From: Mark Roberts <mark.roberts@qcdevelopment.net>
Sent: Tuesday, May 2, 2017 6:44:52 AM
To: Scott Wright
Cc: Daniel Geary jr; Laura Francis; Beth Moncata; Bachman, Melanie; 'rdarin@valleyshore911.org'; CSC-DL Siting Council; Carl Aquilina
Subject: RE: Town Concern - CT5841, BU - 806364, Site Name - HRT 106(B) 943202, App ID - 383797, Customer Site ID - CT5841, Customer Site Name - Durham Central

From: Scott Wright [<mailto:swright@townofdurhamct.org>]
Sent: Friday, April 28, 2017 12:25 PM
To: Mark Roberts <mark.roberts@qcdevelopment.net>
Cc: Laura Francis <Lfrancis@townofdurhamct.org>; Beth Moncata <bmoncata@townofdurhamct.org>;
Bachman, Melanie <Melanie.Bachman@ct.gov>; Daniel Geary jr <gearydan@me.com>;
'rdarin@valleyshore911.org' <rdarin@valleyshore911.org>
Subject: Proposed modification CT5841/143R Old Blue Hill Rd, Durham, CT/EM-cing-038-170417
Importance: High

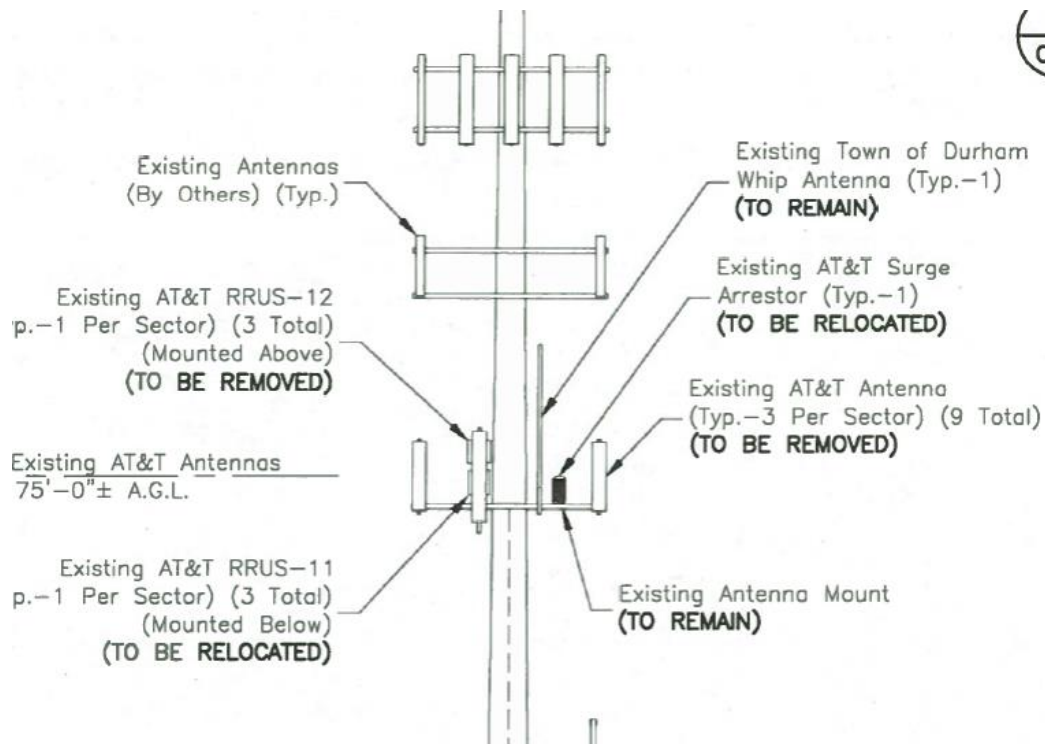
Mr. Wright – thank you for reaching out with this very valid concern. I quickly reviewed the project documents this afternoon and noticed a discrepancy between Crown Castle’s structural analysis and the AT&T project drawings in this respect. Crown Castle, who own the tower, show the Town’s antenna and the platform mount remaining (see below), whereas the Construction Drawings indicate that the mount will be removed. I’m sure that the Crown version of events is the correct one as they would not permit AT&T to remove a mount with someone else’s antenna equipment on it but I will get to the bottom of this right away and advise the group.

Here is the relevant excerpt from the Page 4 of the Crown Castle structural analysis. Only equipment noted with a “3” is to be removed, whereas the whip antenna (DB636-C) and platform mount (LP 1201-1) are both marked as “1” (existing).

I have very significant concern regarding this proposed modification as it proposes removing the mount at 73' on this facility, upon which the Town of Durham has an existing antenna that is used for public safety purposes.

Please advise suggestions as to how to accommodate our public safety requirements while achieving your objectives. We must maintain at least 20' separation between the antenna mounted at 120'.

Scott – as promised, please see the attached revised drawings. These now show that the Town's whip antenna and the platform mount @ 173' AGL will remain.

Crown does not plan to relocate the platform or the whip mounted at 73'. Please revise the CD's to reflect the structural analysis, dated 3/22/17, to leave the platform and the town's whip at 73'.
